NRC Meeting Chapter 18 Human Factors Engineering

Rockville, MD

December 8, 2009

Detailed OER Methodology

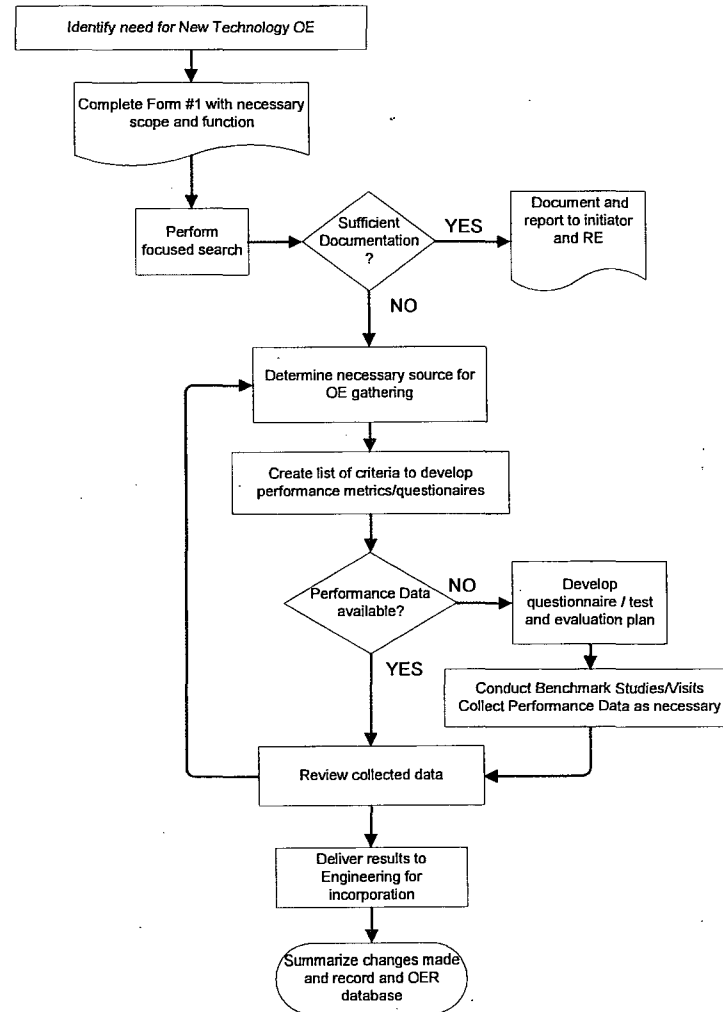
- ▷ **Section 3.4.1 of NUREG-0711 (criterion 3) states: The OER should address related HFE technology. For example, if touch screen interfaces or computerized procedures are planned, HFE issues associated with their use should be reviewed.**

Section 3.2.3 of the EPR OER implementation plan provides lists of non-nuclear industries to solicit for OER, as well as a listing of types of related HFE technology. This section also contains a listing of website databases from which OE in advanced HFE technology may be found.

More information is needed for this section of the implementation plan. Provide to the Staff a detailed methodology for collecting this information, including how the data collection will take place and the sequence of events for the review and evaluation.

- ▶ **NUREG-0700 and NUREG-0800 are satisfied with the OER implementation plan description of section 3.2.3 “HFE-related technology”. The detailed method for collection of New Technology HFE data is described in detailed OER work plan. Figure 5-2 of this section shows a flow chart of the process to determine to what extent this collection should be. This also describes the sequence of events step-by-step for collection, review, and evaluation of this information.**
- ▶ **Detailed methodology is provided in site specific OER work plan (procedure).**

- ▷ Recognize need for new technology OE review. Fill out needed information on App. C form
- ▷ Deliver to HFE Team

1. Complete form for Necessary OE review for new technology in App. C along with initiator
2. Perform focused search for required new technology information. It may be necessary to look in alternative databases in addition to those for the nuclear industry. The following are possibilities for the inclusion in new technology searches. This is not meant to be an exhaustive list. These databases contain various HFE-related topics including HSI issues, training, communications, procedures, and crisis handling.

OER Detailed Work Plan Section on Interviews

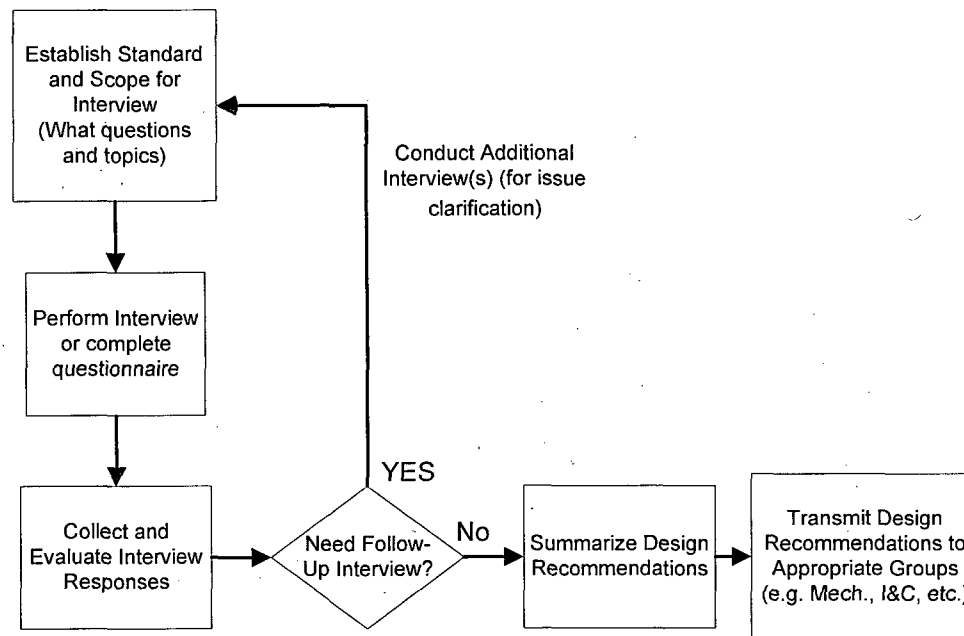
- ▷ **Section 3.4.1 of NUREG-0711, Criterion 4 states “Personnel interviews should be conducted to determine operating experience related to predecessor plants or systems.”**

- ▷ **Section 3.2.4 of the EPR Operating Experience Review (OER) implementation plan describes the methodology for conducting the interviews for the operating experience review. Staff is aware that documents referenced and identified in the OER implementation plan, such as “Human Performance Characterization in Nuclear Events,” dated January 2007, may address some of this information. However, the staff inquires how guidance from this and similar OER reference documents will be used to obtain the operating experience information.**

- ▷ **In addition, according to Section 3.2.4 of the OER implementation plan, the applicant intends to obtain operator information on plant performance through interviews of plant operators. However, the processes for identification and sampling of operators, and the methods to obtain unbiased interview information, are unclear to the staff, based on the information presented in the implementation plan.**

- ▷ **Provide the methods to be used for operator identification and sampling, and the manner in which interview questions will be developed, and interviews conducted**

- ▷ **NUREG-0700 and NUREG-0800 are satisfied with the OER implementation plan description of section 3.2.4 “Operator Interviews.” The detailed method for collection of operator interviews is described in OER detail work plan (procedure). Figure 5-1 of this section shows a flow chart of the process to perform the interview process. This also describes the sequence of events step-by-step for collection, review, and evaluation of this information. OER IP changed to simply state:**

- ▷ **The category of interviews contains both physical interviews and surveys in the form of standardized questionnaires. This allows for the capture of data that would otherwise not have met the threshold for operating experience reports. The overall process for administering the operator interviews is shown in Figure 3-1. This process can also be utilized in conjunction with section 3.2.3 for collecting new technology data.**
- ▷ **Individual interviews will be run upon a sample of nuclear plant personnel involved in operations. Additional surveys will be used to clarify unsolved issues (See Figure).**

1. Determine the system(s) to be the subject of the interview. This may include several systems if the topic for example is ventilation or breakers.
2. Develop standard questions for the subject of the interview. This should include HFE topics relevant to the system.
